21-140ARB-MPR – 94 FRANKLIN STREET – CRONE RESIDENCE

Construction of an approximately 1,225-square-foot addition to the rear of an existing home, located on a 0.35-acre site in Historic Dublin.

2. Overview

Site Layout

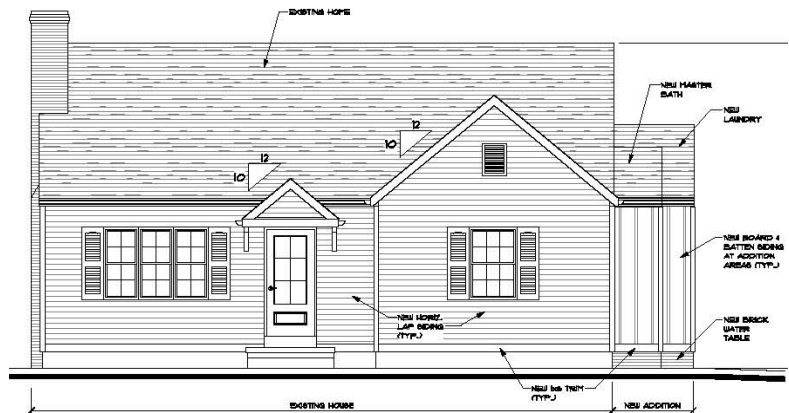
The applicant is proposing to connect both the existing home and the detached garage on the site with this addition. The footprint of the addition has been modified since the Informal Review in October, with the addition extending 0.67 feet to the north of the existing home, and 6.67 feet to the south of the existing home. In coordination with comments from the Board, the applicant has pushed the extensions of the home further east on the lot, closer towards the garage to the rear of the home. The addition meets the minimum 4-foot side yard setback required for lots along Franklin Street. The site plan includes both a new terrace and deck to the northeast of the addition; however, the applicant has indicated that the deck and terrace are not currently designed. The applicant will be required to receive approval of the deck and terrace with the Board at a future meeting.

Additionally, the applicant is proposing to remove the existing driveway from Franklin Street. This will result in the property having a single vehicular access point from Mill Lane to the east. The proposed improvements to the site result in a total lot coverage of 35.3 percent, and a building lot coverage of 18.5 percent. Both lot coverage calculations meet the Code requirements.

2) North Elevation – Side Yard

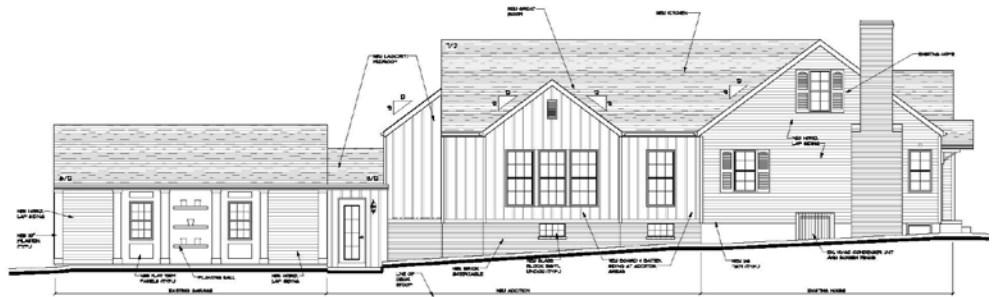
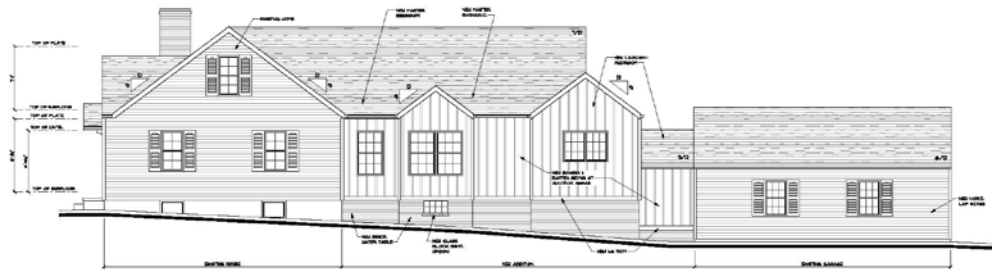
The north elevation contains the side gable of the existing home, with the majority of the addition having a gable perpendicular to

the existing structure, and two additional side-gabled push-outs. This elevation accommodates a slight change in grade from front to rear. The proposed addition has increased in height over the Informal Review to meet the ridgeline of the existing home, where previously the addition stepped down toward the garage. The addition will no longer require the removal of one existing window opening on the north elevation, as the applicant will connect the addition on the inside of the east elevation of the home, preserving the corner of the existing home. A proposed hyphen between the addition and the garage will create an attached garage.

The building addition is proposed to be clad in new engineered-wood vertical board and batten siding (LP Smartside) in a white (BM OC-57 White Heron) cedar-textured finish. A detail of the board and batten has not been provided by the applicant specifying the texture and batten widths. A recommended condition of approval is provided to require the applicant to provide a material detail of the board and batten based on the suggestions provided by the Board, subject to Staff approval. A burgundy thin-brick (Acme Brick) watertable is carried along the foundation of the new addition. Thin-brick is not a permitted material within the Historic District and would require approval of a Waiver.

The applicant is proposing new and replacement 4-over-4 and 6-over-6 black aluminum-clad double-hung wood windows, with shutters only located on the existing home. The addition will be sheathed in black asphalt shingles. The applicant is proposing new 10-inch pilasters with new engineered-wood flat trim panels on a portion of the existing garage. The panels and pilasters are proposed to frame a planting wall. Staff would not recommend the use of pilasters or flat panels on the garage as they take away from the minimal nature of home, and are not typical

with Minimal Traditional houses. A recommended condition of approval addresses this. Finally, the applicant is proposing a black Craftsman-style lighting fixture next to a new fiberglass smooth side door (Vista Grange – Masonite) with a six-pane glass window and finished in Tricorn Black. A condition of approval recommends that the applicant select a traditional lighting fixture rather than a Craftsman lighting fixture, subject to Staff approval.

- 1) The applicant include functioning hardware with the installation of the shutters;
- 2) The applicant provide a material detail of the board and batten based on the suggestions provided by the Board, subject to Staff approval;
- 3) The applicant remove the proposed flat panels and pilasters on the north elevation of the garage;
- 4) The applicant shall preserve the original brackets at the front door;
- 5) The applicant select traditional lighting fixtures, subject to Staff approval;
- 6) The applicant provide wood gable vents, subject to Staff approval; and,
- 7) The applicant receive approval from the Architectural Review Board for the future installment of the deck and terrace.

4) *East Elevation – Mill Lane*

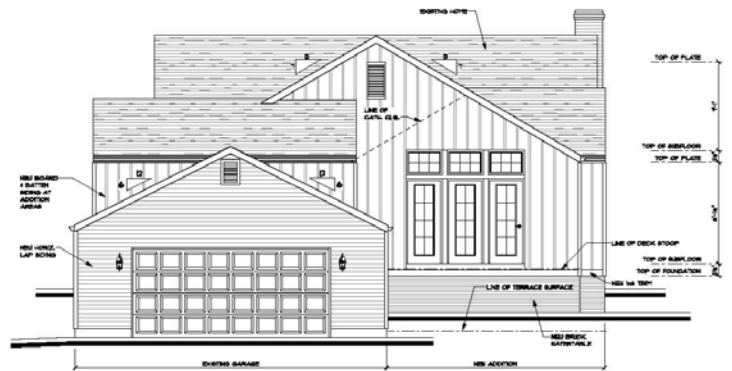
The east elevation’s rooflines have been simplified from the original submittal. The materials proposed are consistent with the other elevations. The applicant is providing three eight-pane fiberglass doors, similar to other doors proposed on the addition, which will lead out to the future deck and terrace. The three doors all include six-pane transom windows above the entrances. Finally, the applicant is proposing Fypon composite gable vents. Similar to previous applications, a condition of approval states that the applicant provide a wood gable vent in lieu of the proposed vent, subject to Staff approval.

Similar to previous applications, a condition of approval states that the applicant provide a wood gable vent in lieu of the proposed vent, subject to Staff approval.
